Land Use Management Committee

Monday 5 September 2005

Planning Report, Recommendation & Appendixes - E Armstrong Planning Pty Ltd

TOWN PLANNING ASSESSMENT REPORT

Figure 1 (on the following page) has been prepared to illustrate how the articulation zone is proposed to operate in respect of Building J. This is a replacement of the indicative floor plan contained at Appendix D in the SEE.

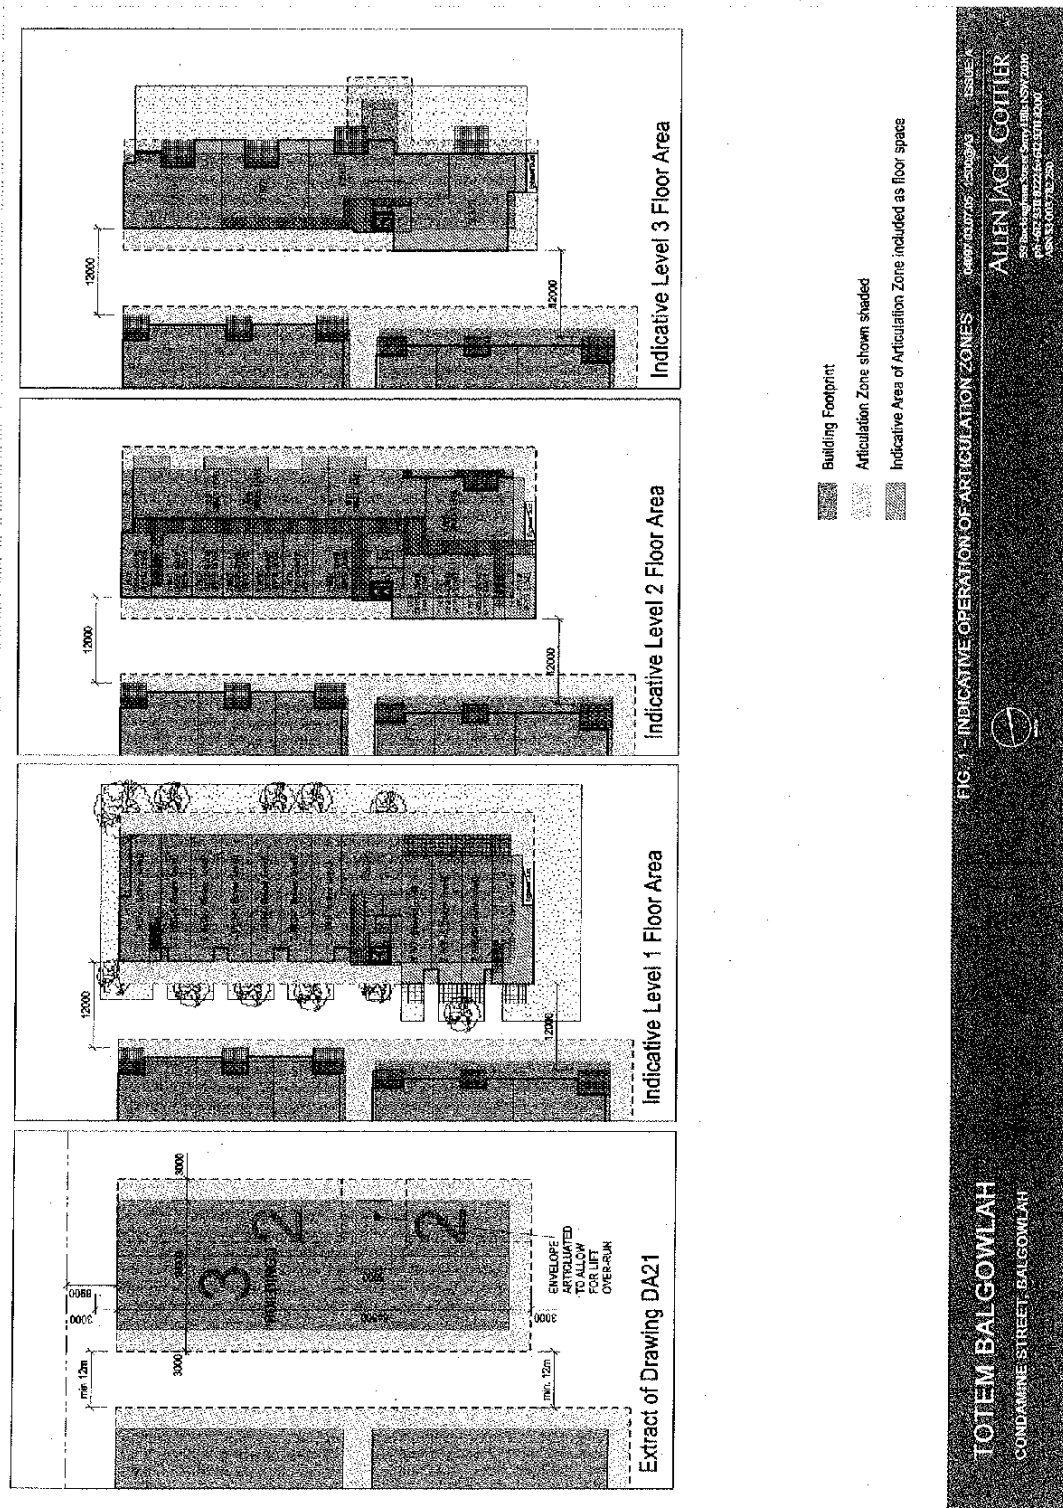
2.1.1 Operation of the Articulation Zone

This plan demonstrates how the articulation zone provides flexibility to ensure a minimum distance of 12m is achieved between the final building location of Buildings G and F in relation to Building J.

Figure 2 – Departure from RL 58.5 Height Control

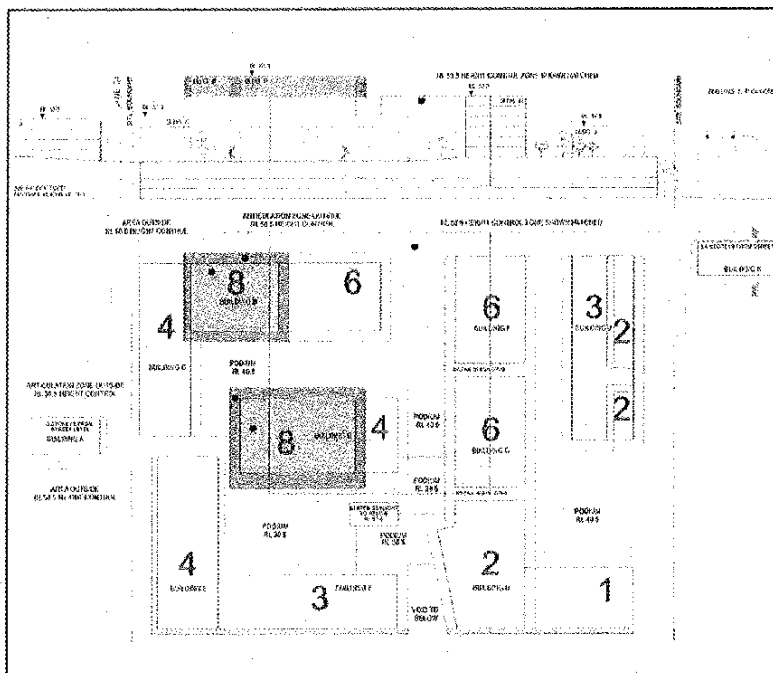
The following **Figure 2** illustrates the extent to which the Stage 1 DA breaches the Balgowlah Urban Design Controls (UDC) height control of RL 58.5.

The building envelope shown in **Figure 2** has been established through the community consultation process leading to the Stage 1 DA submission and dimensionally located so as to have negligible visual and shadow impact. The justification for the building heights shown in **Figure 2** are further outlined in the SEE and Section 3.2 of this submission.

The intent of the Stage 1 DA is to seek general approval for development within the envelopes shown in the drawings and SEE. The design and detailed extent of development will be provided to by Council as part of the Stage 2 DA submission.

Replacement of Figure 20 in S.E.E

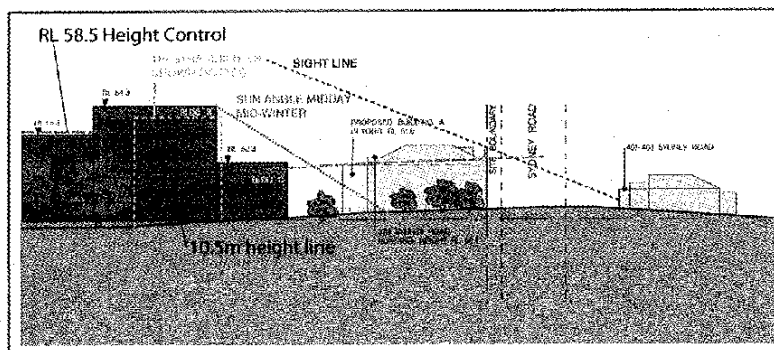
Figure 20 on page 48 of the SEE has been amended below to illustrate the height controls in relation to Building B.

Figure 3 – Public Open Space

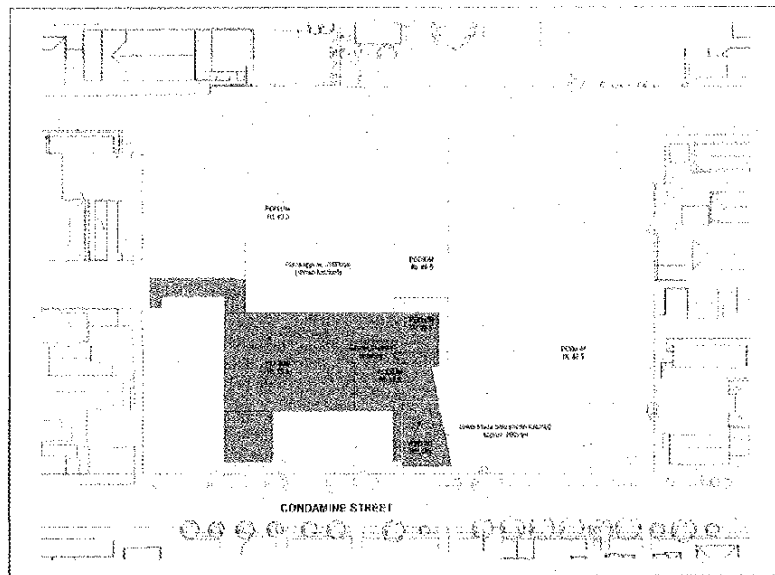
Figure 3 below indicates the calculation of the approximate area of 2300m² public open space area referred to in the SEE.

This 2,300m² incorporates not only the main plaza of approximately 2000m² but also publicly accessible areas such as those leading into the plaza. It is noted that the public plaza is well in excess of the 500m² plaza required by the UDC. An additional public plaza area of approximately 200m² is also proposed at the lower level retail entry.
